# STAFF REPORT

**TO:** Glen Ellyn Architectural Review Commission  
**FROM:** Michele Stegall, Village Planner *MJS*  
**DATE:** February 6, 2015  
**FOR:** February 11, 2015 Architectural Review Commission Meeting  
**SUBJECT:** Pre-application Meeting  
Main Street Parking Lot, Giesche and St. Petronille Properties

**REQUEST:** Pre-application meeting regarding the potential redevelopment of the Main Street parking lot, Giesche and St. Petronille properties with a 5-story mixed use development that would include 7,040 square feet of ground floor retail and approximately 125 upper floor, luxury, rental apartments. A new 2 or 3 level parking garage is also proposed with a potential gain of 76-202 new public parking spaces being created with the project.

MAIN STREET ELEVATION

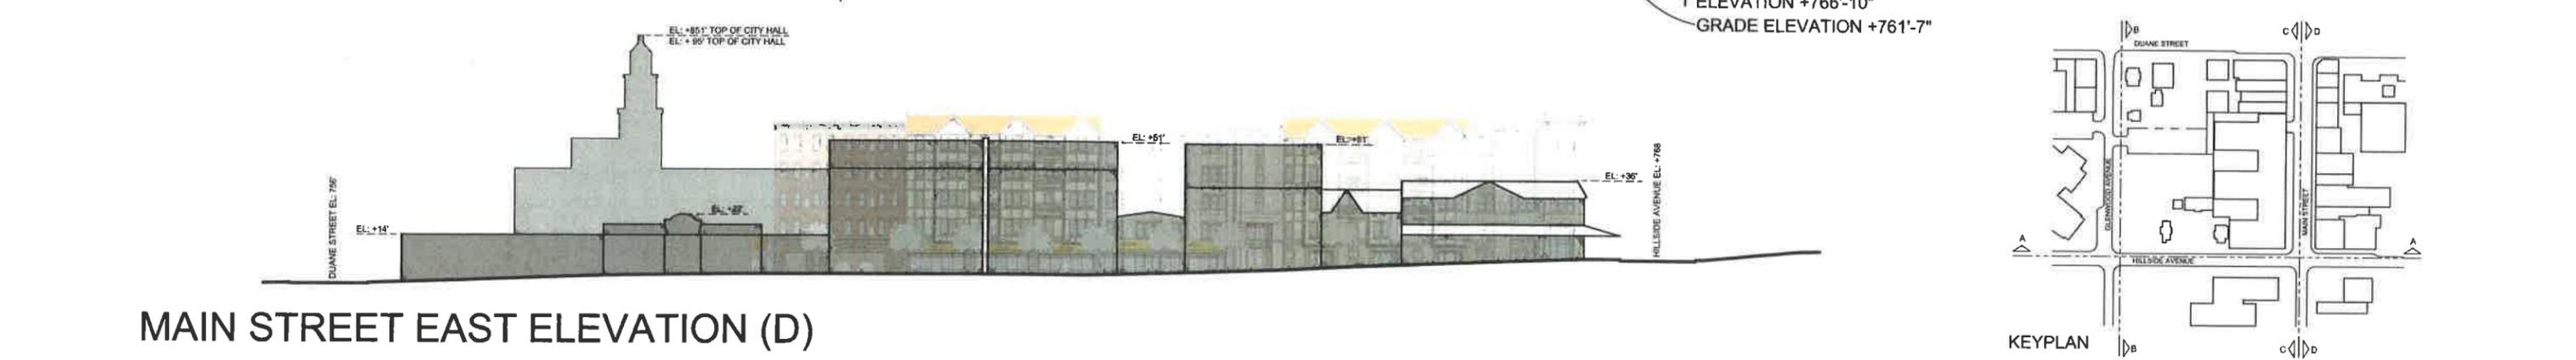
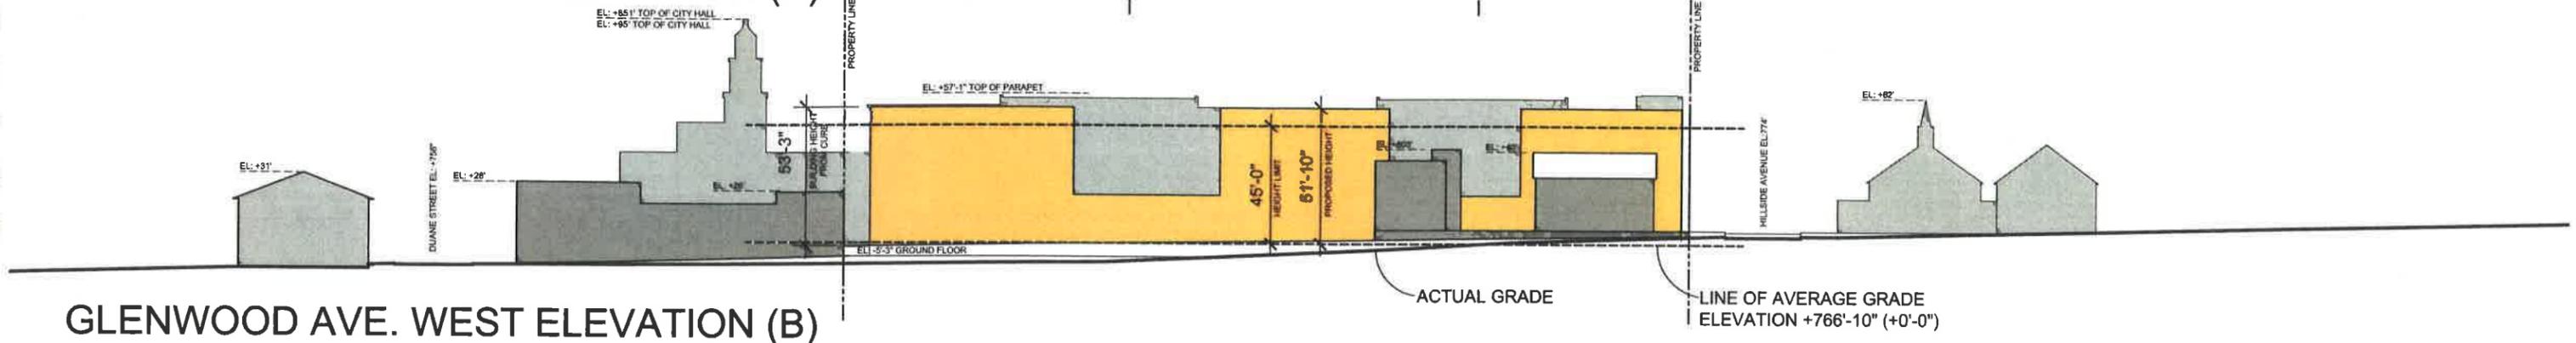
The petitioner is proposing to use three different architectural styles on the Main Street and Hillside Avenue facades including Tudor, Italianate and Italian Renaissance. Brick, cultured stone and stucco are proposed as the main building materials. Additional information about the proposed building materials is included in the petitioner's pre-application packet. All of the materials, with the exception of the wood trim on the Tudor building, are encouraged by the Appearance Review Guidelines. The use of wood is discouraged for reasons related to durability and maintenance. Therefore, the Commission may wish to discuss this issue with the petitioner, and inquire if another material, such as a cementitious siding, could be substituted.

**Number of Facades.** The building is proposed to be broken up into 5 different facades fronting on Main Street and two different facades fronting on Hillside Avenue. This approach was encouraged by staff in an attempt to create a building that would appear to “complete” Main Street and provide a feeling of separate buildings constructed over time as opposed to one large building. There are 7½ distinct buildings with varying widths located on Main Street across the street from the site. In reviewing the project, the Commission may wish to consider how the number and widths of the proposed facades would fit in with the rhythm of Main Street.

**First Floor Treatments.** Approximately 7,000 square feet of retail is proposed on the first floor of the building fronting Main Street. Traditional storefront windows are proposed in this area. Awnings are also planned to give the building more of a pedestrian feel along the retail frontage. Large windows are proposed along much of the remainder of the first floor consistent with much of the downtown. Parking is planned behind many of these windows with the parking floor dropping below sidewalk level in some areas. The Commission may wish to inquire about what type of window treatments (i.e. clear glass, spandrel glass or other materials) are proposed in these areas and if the parking would be visible through the ground floor windows.

GLENWOOD PARKING DECK ELEVATION

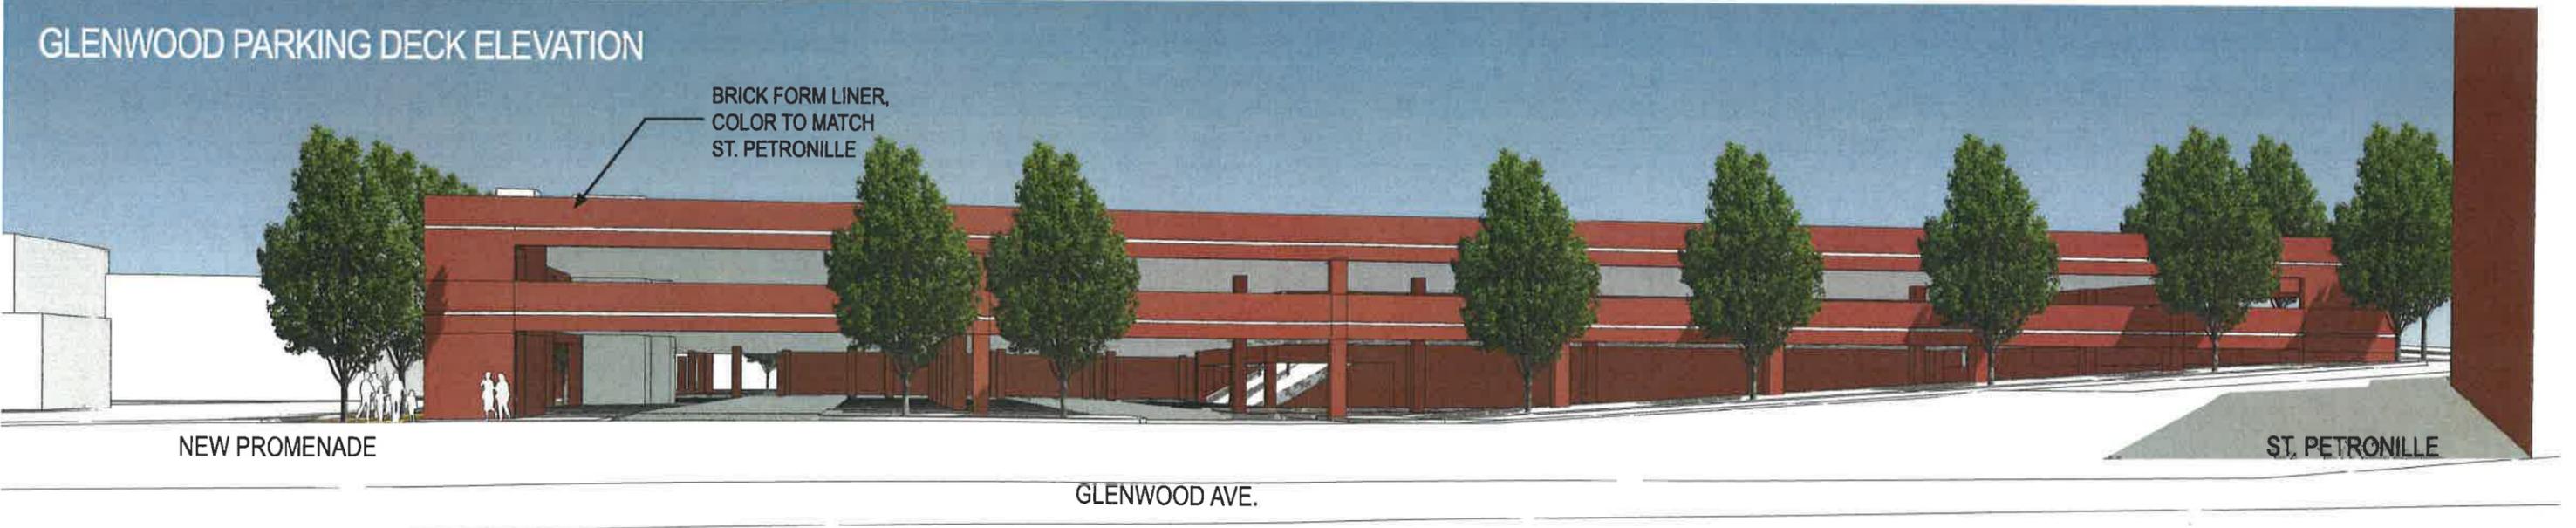
**Parking Deck.** A 2 or 3 level parking deck is proposed behind the building on property owned by St. Petronille. At this time, it is anticipated that the Village would enter into a long term, no-cost lease to construct, own and maintain the parking structure on St. Petronille's property. Conceptual massing drawings of the deck are included in the petitioner's pre-application packet. The deck is currently proposed to be constructed with pre-cast concrete and brick form liners. The petitioner will bring pictures to the meeting of other garages that utilize the same materials and design treatment envisioned for the garage.
